BECHTEL INVESTIGATION  
INTO CAUSES  
OF DIESEL GENERATOR  
BUILDING SETTLEMENT

Consumers Power Company  
Midland Plant Units 1 and 2

SUBJECT: MCAR 24 (issued 9/7/78)  
 Settlement of the Diesel Generator Foundations and Building  
 INTERIM REPORT 4  
 DATE: February 16, 1979  
 PROJECT: Consumers Power Company  
 Midland Plant Units 1 & 2  
 Bechtel Job 7220

D.G. Building - Meeting at Bechtel.  
with Consultants Hendron, Davisson and Gould.  
May 10, 1979. Thursday

FIGURE No. 19

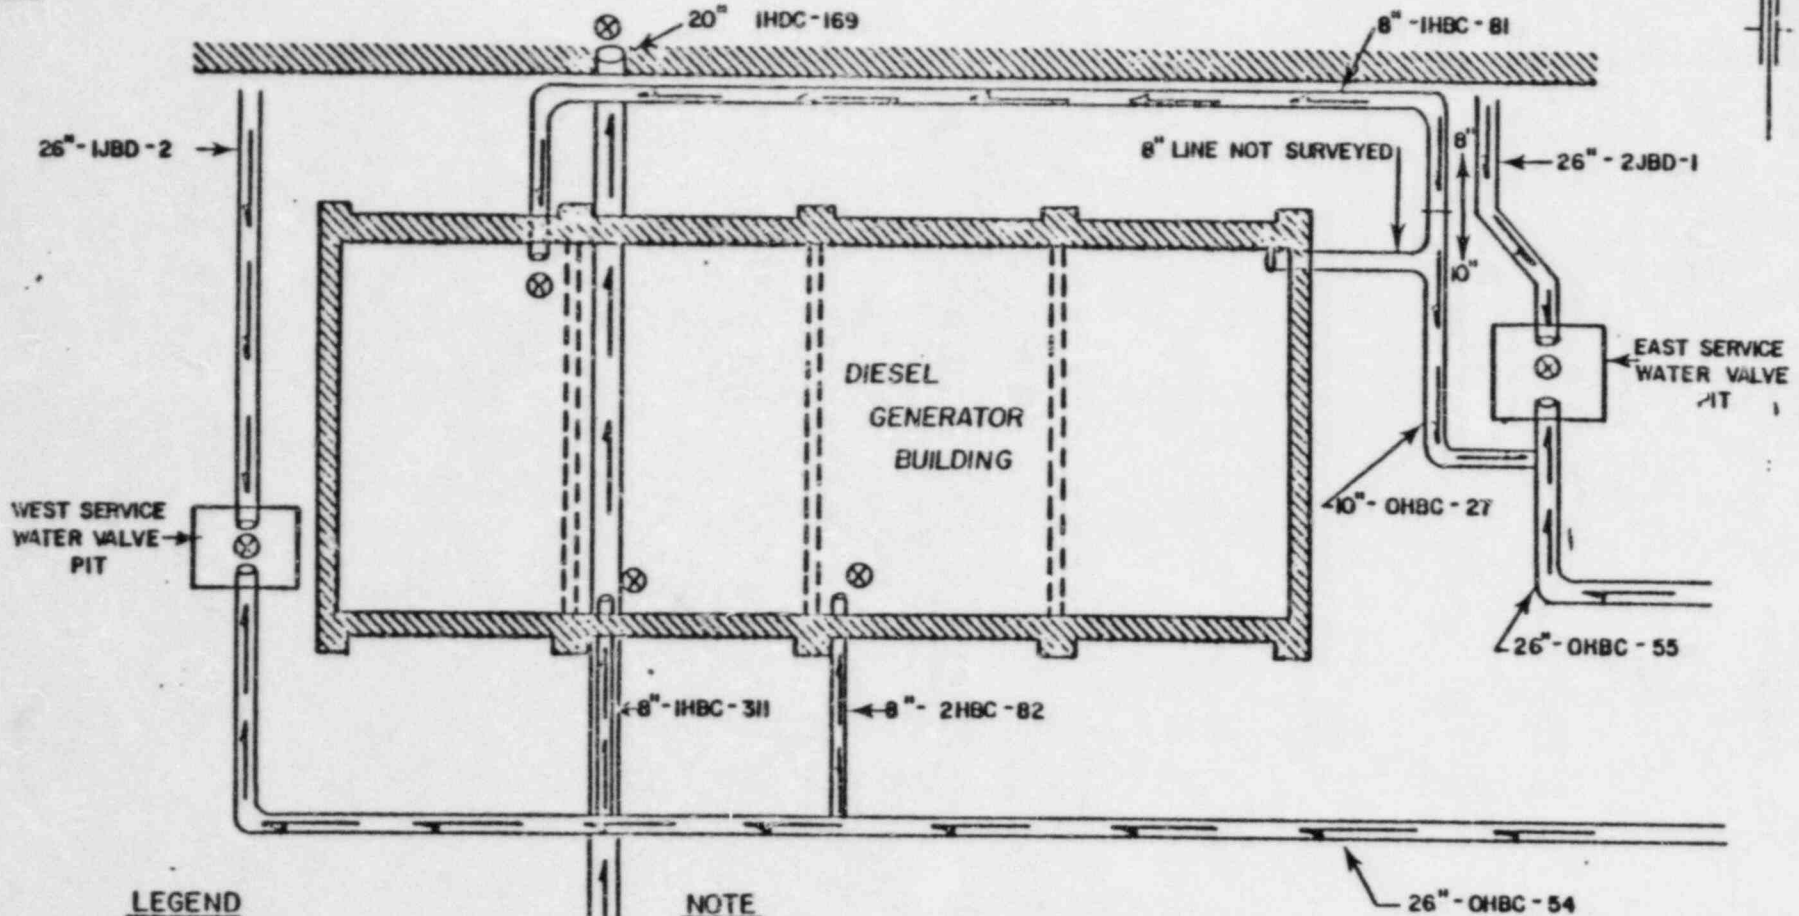
Fig 1 needs to be revised prior to review
